**Subject: Modification in Generation Licence No. 003/SGC/2001 dated 27.08.2001 –
ICI Pakistan Powergen Limited**

GENERATION LICENCE

No. 003/SGC/2001

**Modification to Schedule-I of
 Generation Licence
 No. 003/SGC/2001**

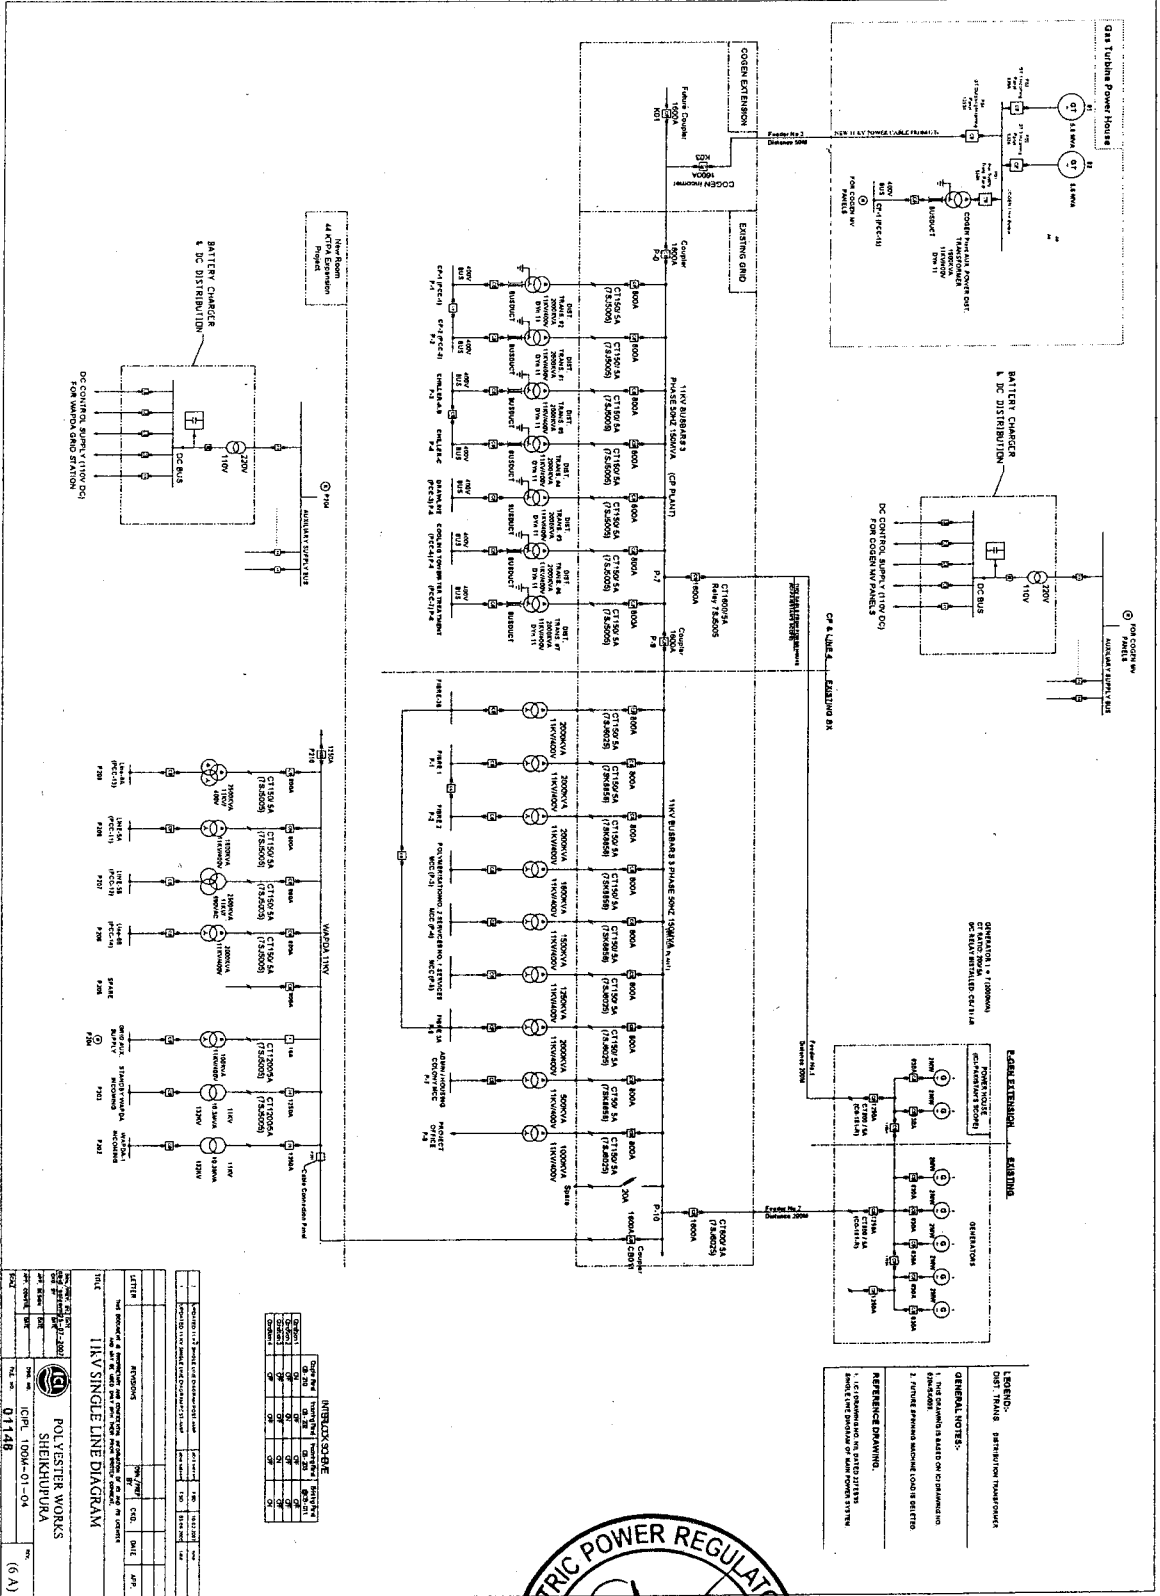
The Network Facts given at items “A, B, C and F” of Part A of the Schedule-I are hereby replaced in its entirety with following:-				
A.	No. of Feeders	Three (03)		
B.	Length of Each Feeder (Meter)	F1	F2	F3
		200 Meter	200 Meter	50 Meter
C.	Length of Each Feeder (Meter) to each Consumer	F1	F2	F3
		200 Meter	200 Meter	50 Meter
F.	Whether connection with DISCO's Network exists (whether active or not), if yes provide details of connection arrangement (both Technical and Contractual)	<p style="text-align: center;">Yes (being used as back up system only single diagram attached)</p>
